31/6-91B 3934 Baltimore Street,
Kensington

Re: Removal of White Pine
tree

HISTORIC PRESERVATION COMMISSION STAFF REPORT

CASE NUMBER: 31/6-91B

@ 6" above ground:

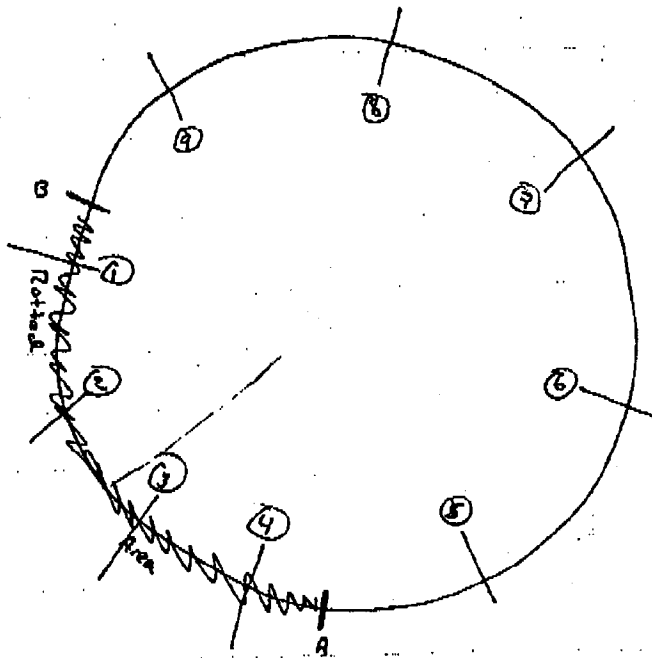
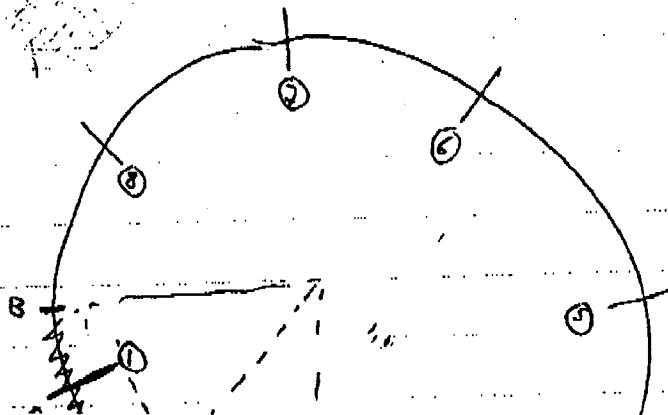
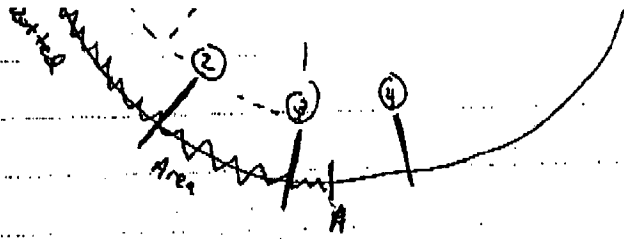
At 6" above grade a total of 9 holes were bored into the trunk. Four of these holes were bored directly into the face of the rotted area (39 inches wide). The rot extends at least 9 inches into the trunk (the length of the bit). The other five sites yielded 9 inches of normal looking wood. I suspect that the rotted area here resembles a wedge shape.

At 4.5' above grade 8 holes were drilled. Those into the face of the rotted area (26 inches wide here) yielded either rotted or semi-rotted wood to a depth of 9 inches. The other sites yielded good wood to a depth of 9 inches. Again, I strongly suspect that the rotted area of the trunk here resembles a pie shaped wedge.

Using a formula to determine theoretical strength loss in trees, we can objectively evaluate whether or not a tree presents a hazard to surrounding areas. I have concluded that the theoretical strength loss suffered by this White pine is 40% at the base and 29.5% at 4.5' above grade. The generally accepted cut off point for considering a tree a "hazard" is 33%. Complicating this situation are three additional factors: 1) The rotted area spirals down the trunk. This would seem to be an inherently weaker situation than if the rot extends straight down the trunk. 2) Pines are soft wooded and have less structural strength than hardwoods such as Oaks. 3) This tree is very tall and is exposed to winds, especially in the winter when the surrounding deciduous trees have shed their leaves.

In light of the above information, I would suggest that the tree either be removed entirely or topped out to lessen the likelihood of wind throw during storms. As with any situation dealing with potentially hazardous trees, TREEMASTERS cannot predict the future with certainty and cannot be held liable for any damage that may occur. This tree may stand for years with no danger to you or the house; on the other hand, it may topple over tomorrow. There is just no way of saying. The safe and conservative approach would be to remove the tree entirely.
